MIL-M-28787/48A(SH)
AMENDMENT 2
19 July 1991
SUPERSEDING
AMENDMENT 1
29 December 1982

MILITARY SPECIFICATION

MODULES, STANDARD ELECTRONIC

DRIVER, TRANSLATE, DIGITAL, KEY CODE MDP

FIGURE 3 Transient thermal test circuit

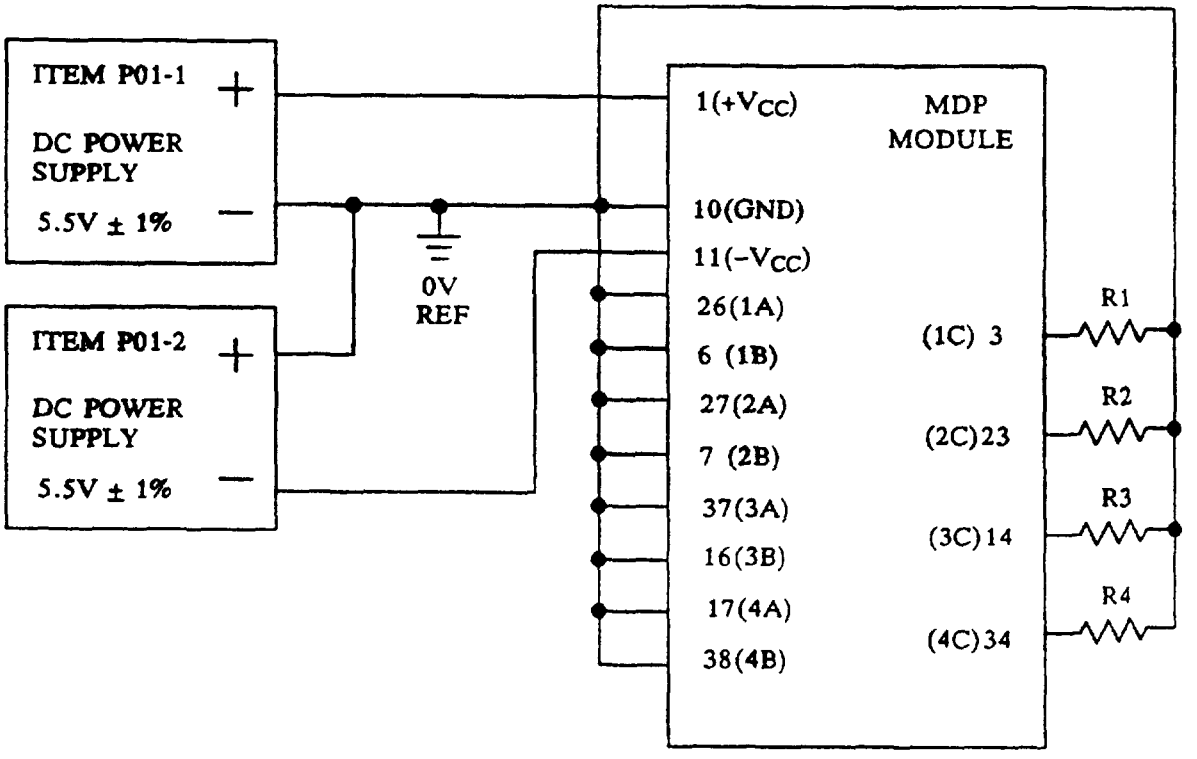
FIGURE 3 Delete and substitute new figure 3 as printed on page 4 of this amendment.

NOTE R1-R4 = 5 9kΩ ± 1%, 1/4W

FIGURE 4. Vibration test circuit.

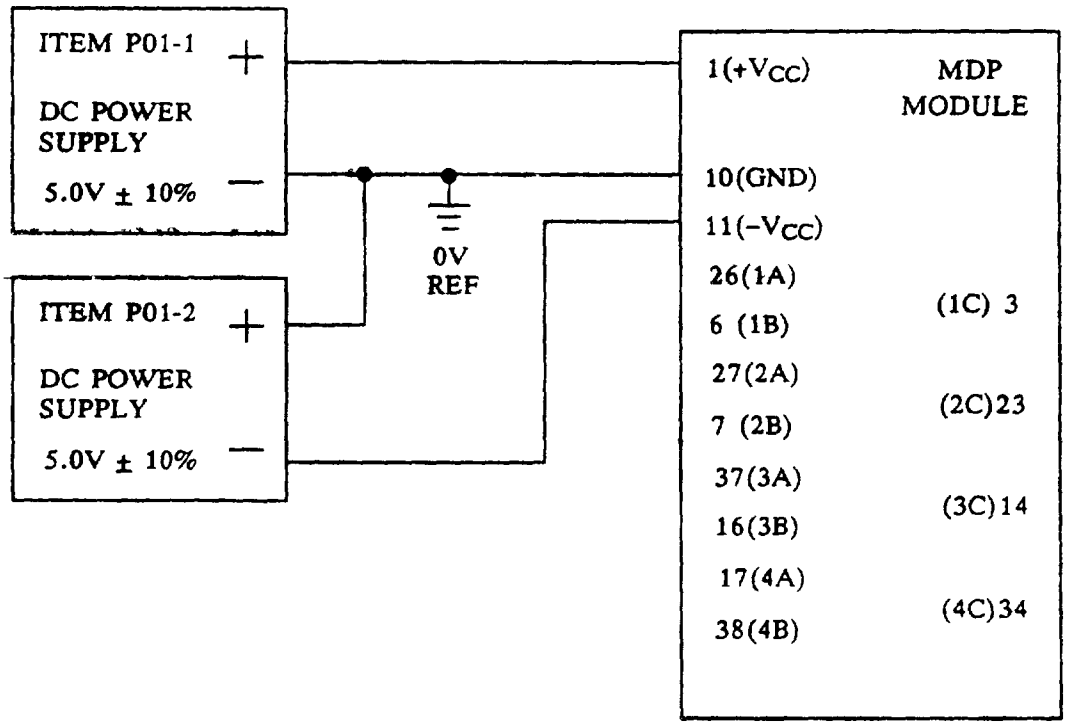
* FIGURE 4· Delete and substitute new figure 4 as printed on page 5 of this amendment

FIGURE 8 Output voltage (high-level and low-level) test circuit for tables VI and VII

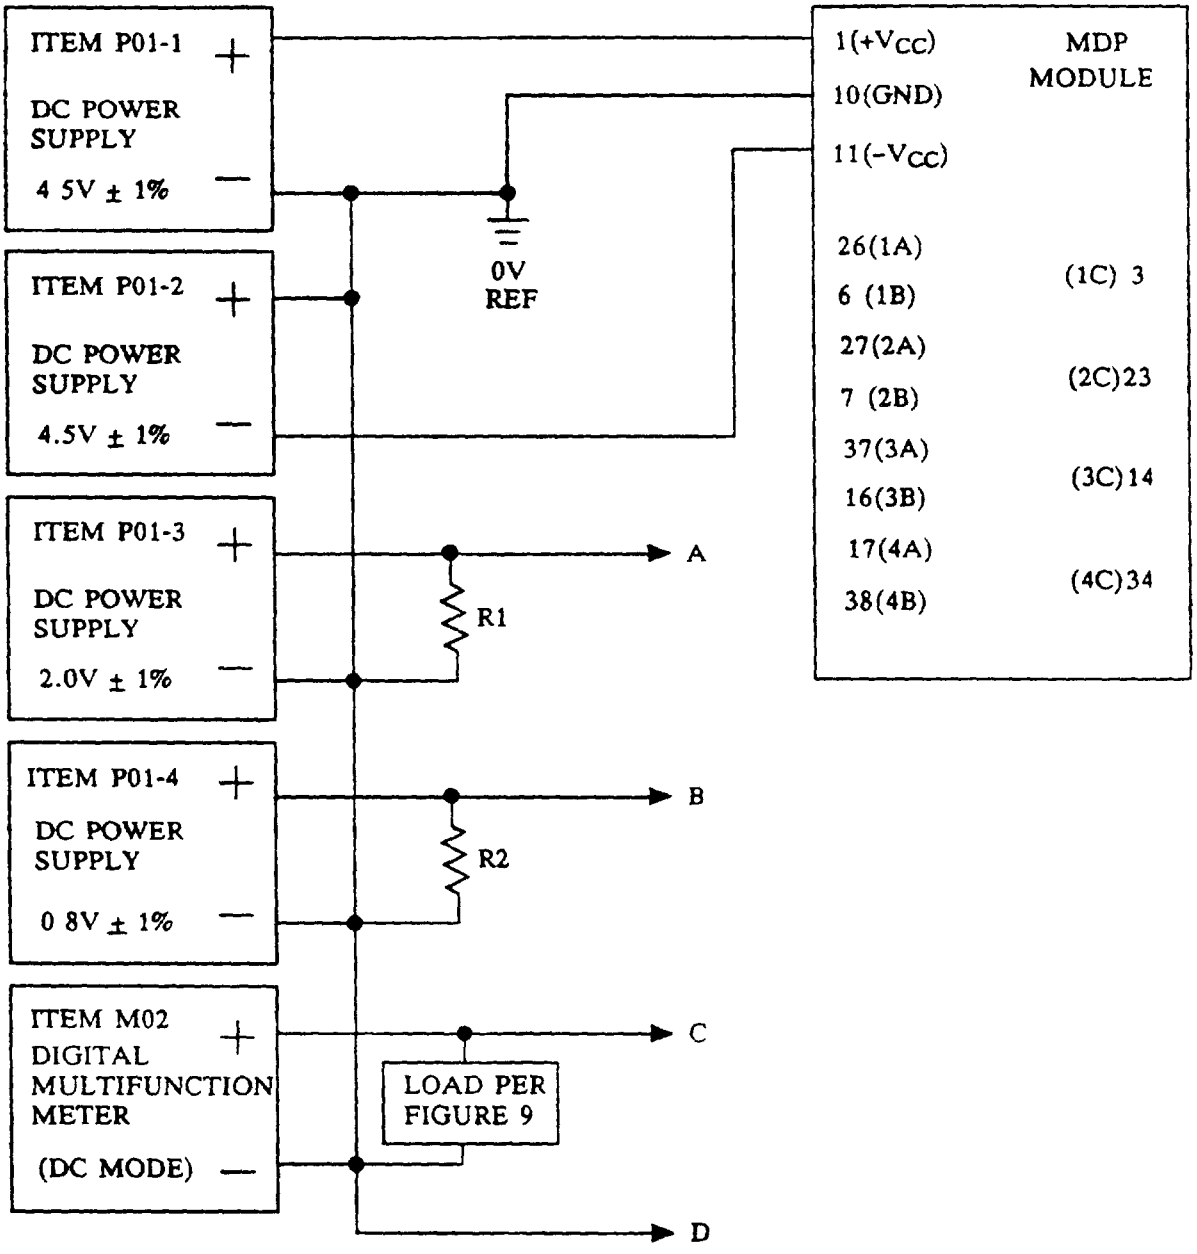
FIGURE 8: Delete and substitute new figure 8 as printed on page 6 of this amendment

NOTES:
1 R1 = R2 = 51Ω ± 5%, 1 W
2 After connecting points A, B, and C and prior to making each measurement, apply point D to point C for a minimum of 1 second, then remove point D from point C.

FIGURE 15 Power supply transient amplitude ($+V_{CC}$ and $-V_{CC}$) test circuit waveforms for table XII

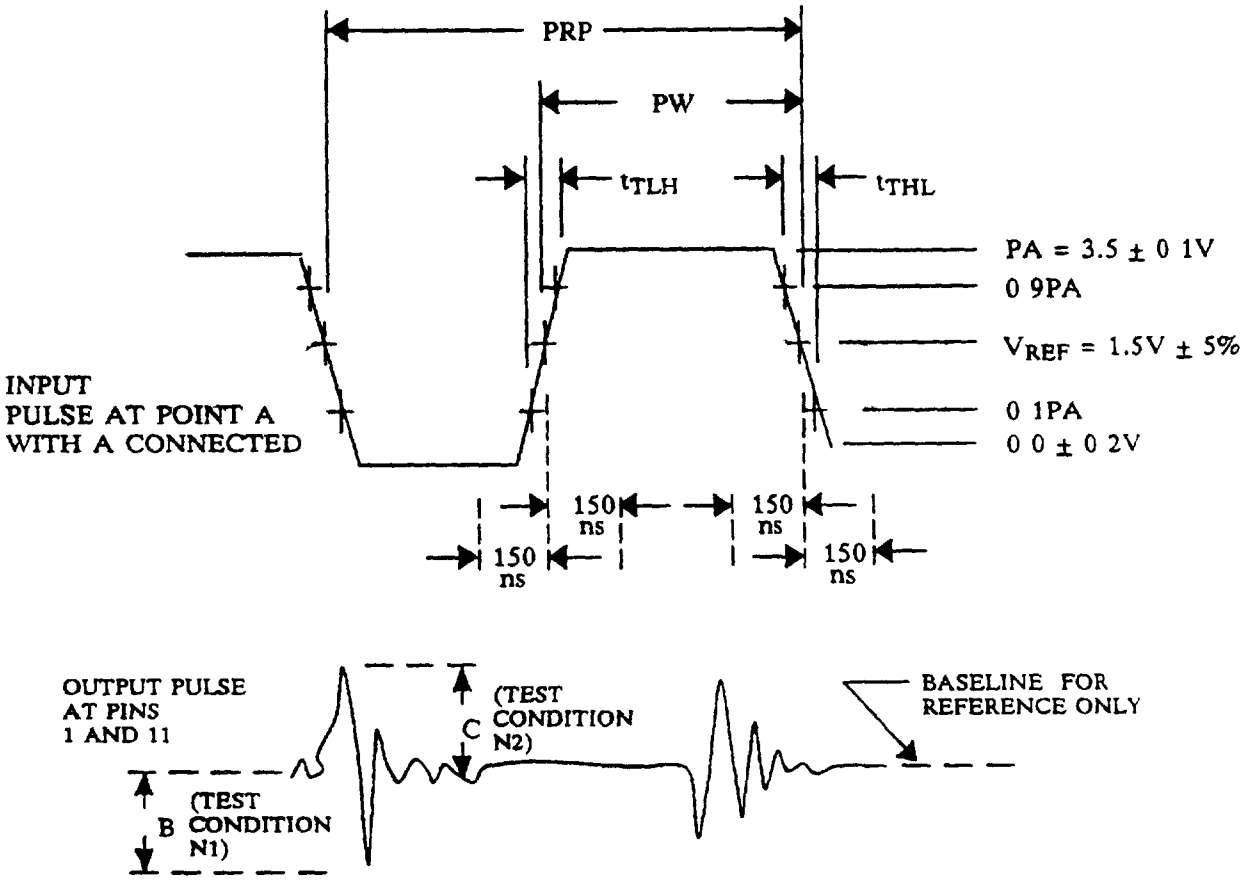
FIGURE 15: Delete and substitute new figure 15 as printed on page 7 of this amendment.

1 Input pulse parameters·
PW = 1µs ± 10%
PRP = 2µs ± 10%.
$t_{TLH} = t_{THL}$ = 10 ± 2ns

2. Amplitude B is measured from the baseline to the most negative excursion of the pulse, which may occur in time coincidence ± 150ns with the 1.5Vdc point of either the leading edge or the trailing edge of the input pulse.
3. Amplitude C is measured from the baseline to the most positive excursion of the pulse, which may occur in time coincidence ± 150ns with the 1.5Vdc point of either the leading edge or the trailing edge of the input pulse
